Introduction

A modified A/C Condenser Fan Assembly and Shroud are available for reduced A/C condenser fan noise.

- 1994 and 1995 Model Year 4Runners.

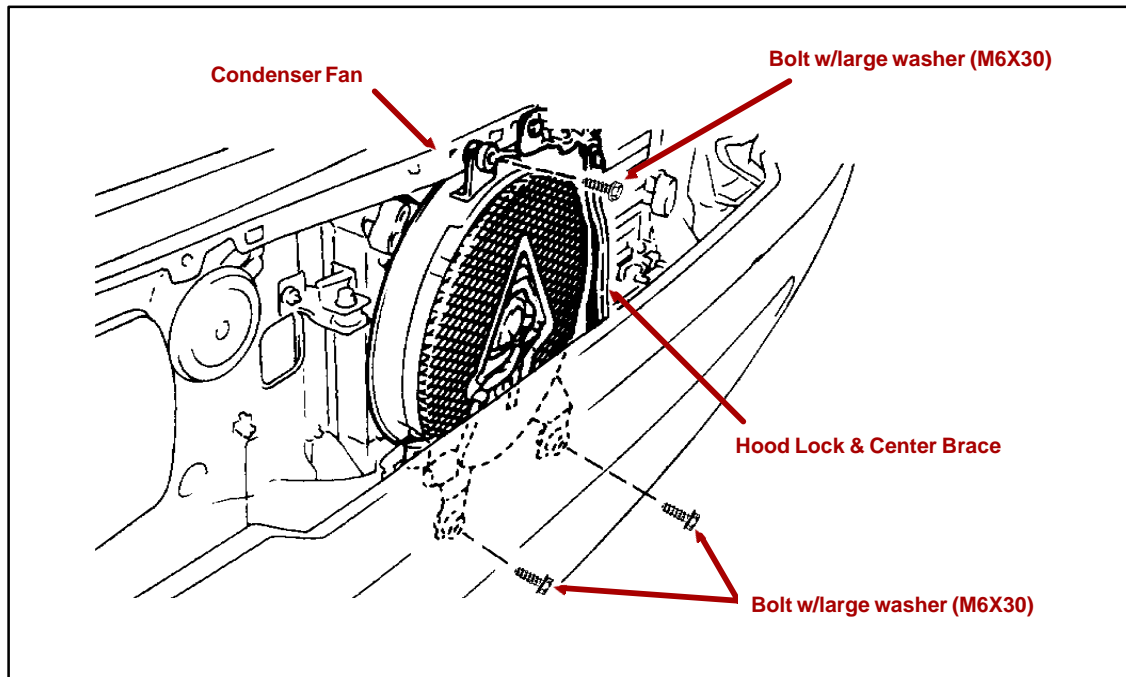
Installation of the modified A/C condenser fan on vehicles used under severe conditions (i.e. heavy loading, towing or rough road use, etc.) is not recommended as the cooling capacity of the modified fan is slightly less than that of the original fan.

PART NUMBER	PART NAME
88590-35020	A/C Condenser Fan Assembly with shroud for reduction of fan noise
